MEETING MINUTES
PUBLIC WORKS COUNCIL COMMITTEE
West Des Moines City Hall Training Room
May 13, 2015

**FLOOD HAZARD REVIEW SUMMARY
CITY OF WEST DES MOINES - 190231
MAY 18, 2015**

Existing Roof Observation Report

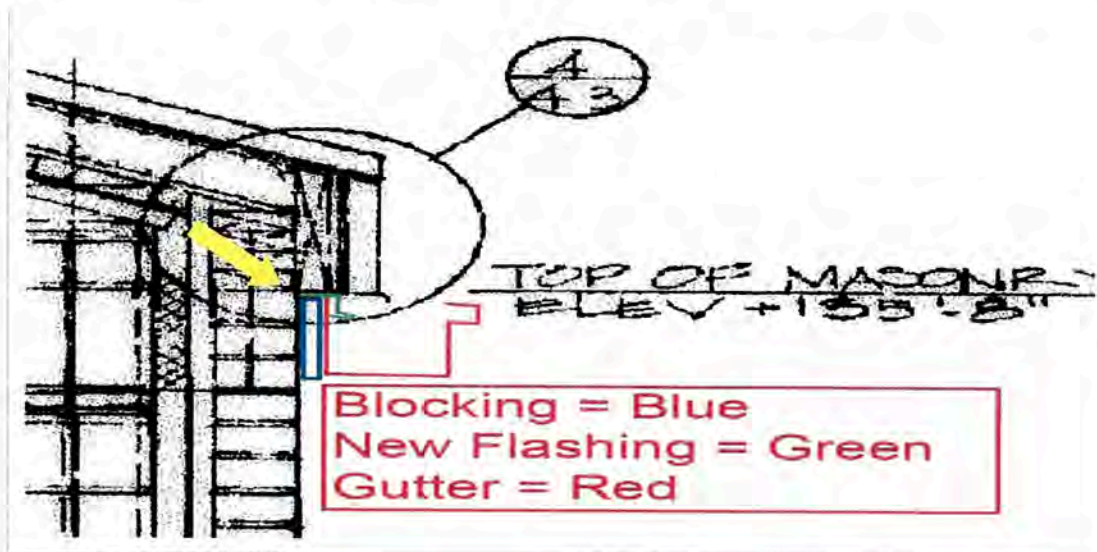
The material installation matched the original construction documents at this location. The Tee-Panel standing seam metal roofing system has a snap-on seam cap with a vinyl weather seal, Figure 1. This snap-on seam cap is located under the Mansard panels. Exterior Sheet Metal (ESM) disassembled one Mansard panel at the EPDM roof line, Figure 2. ESM was unable to remove the snap-on cap without damaging the vinyl weather seal, Figure 3. If the Tee-Panel system needs to be removed to install the new flat roofing system, the snap-on caps and vinyl weather seals will need replaced.

A best practice roofing termination bar installation height requires an 8 inch minimum height from the finished roof deck elevation. To achieve an 8 inch termination bar height, both the Mansard and the vertical wall panels (Figure 4) will need to be field cut. The new roof will terminate directly below the shorten panels. The finished length of both panel systems will be determined by the type of flashings required by the selected roofing manufacturer. SystemWorks recommends reviewing this detail with the selected roofing manufacturer prior to cutting the panels. **Note:** the Tee-Panel's exposed edge may corrode; the corrosion may cause staining at both locations.

Figure 1: Tee-Panel profile (not to scale).

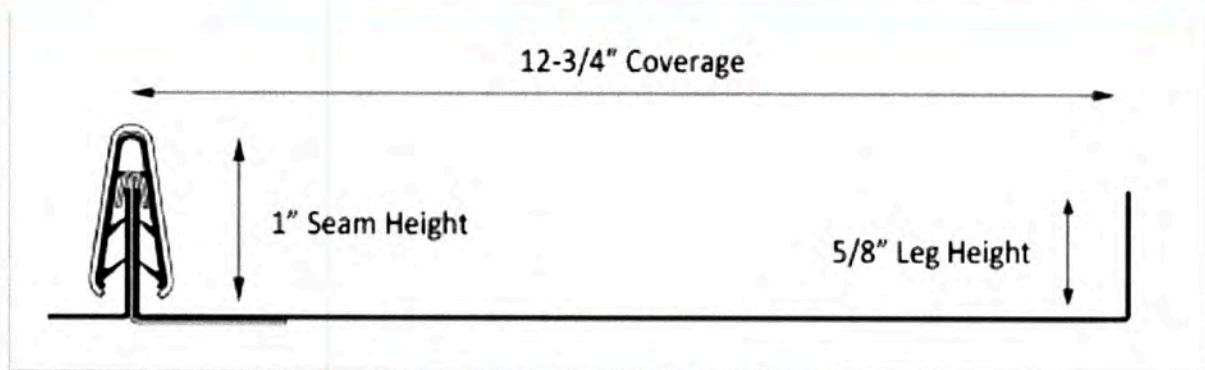
Figure 2: One Mansard panel was removed to review the sill flashing installation and the EPDM membrane termination.

Figure 3: The vinyl weather seal was very brittle and split during the removal of the seam cap (area shown with red arrow).

Figure 4: East Elevation, these vertical Tee-Panels will need to be field cut to allow for the installation of the new roofing system.

Figure 5: The Mansard panels sit on the sill flashing shown above my hand; the EPDM membrane terminates behind the treaded lumber.

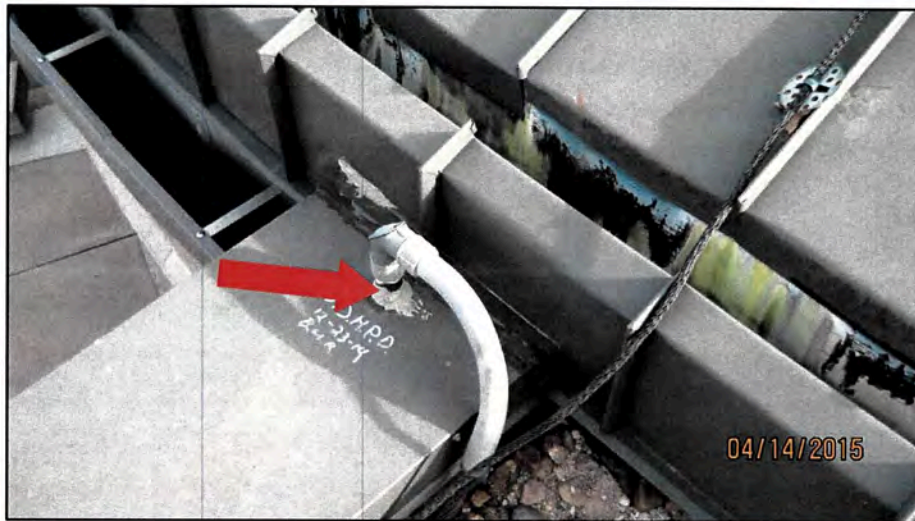
Figure 10: The existing lightning protection system is installed through the center of the coping cap. The sealant at the base of the penetration is starting to fail (area shown with red arrow).

Figure 11: The adhesive base plates are not adhered to the Tee-Panels.

Figure 12: The lightning protection system conduit is not permanently sealed (area shown with red arrow).

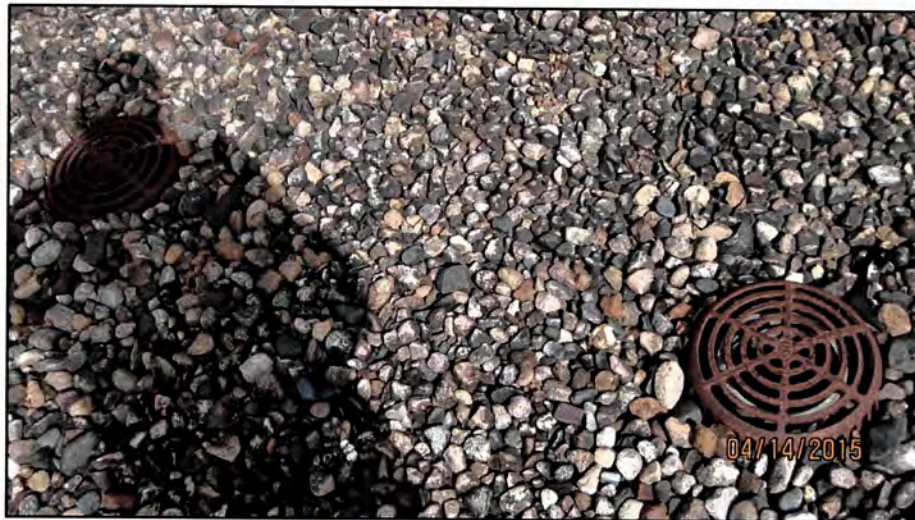
Figure 13: Recommend that all roof drain seals, including over flow drains, be replaced.

Figure 14: Some of the mechanical curb heights need to be raised.

Figure 15: East Elevation, vacant mechanical curb. Roof curbs and penetrations should be capped below the new system to reduce roof penetrations.

Figure 16: North Elevation, it appears ice buildup has damaged this joint.

Figure 17: North Elevation, the Mansard sill flashing joints (area shown with red arrow) are allowing moisture to migrate behind the box gutter (area outlined in red).

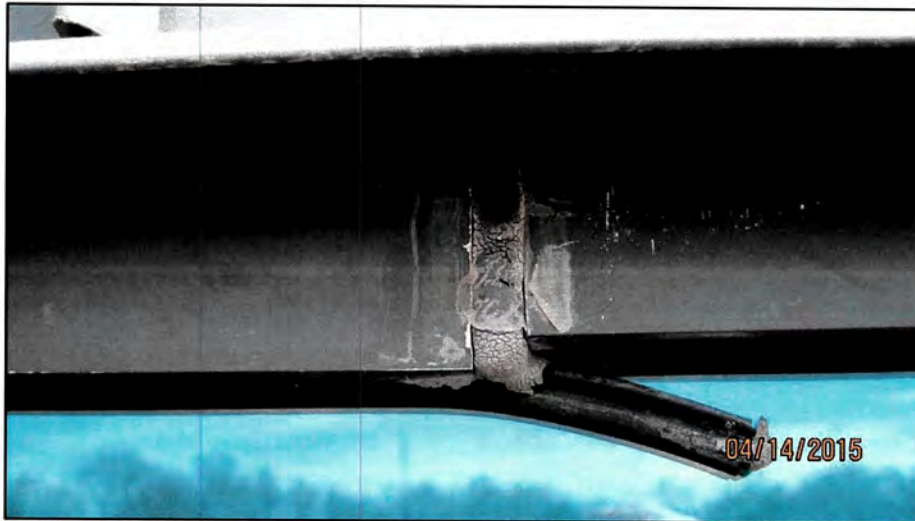
Figure 18: East Elevation, the control joints and gaskets around the exterior windows are separated in multiple locations.

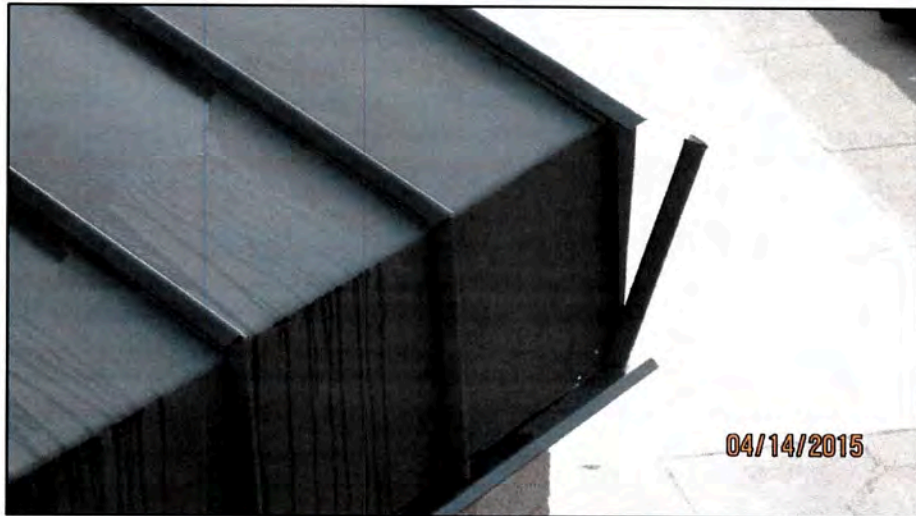
Figure 19: The Tee-Panel seams need repaired in multiply locations.
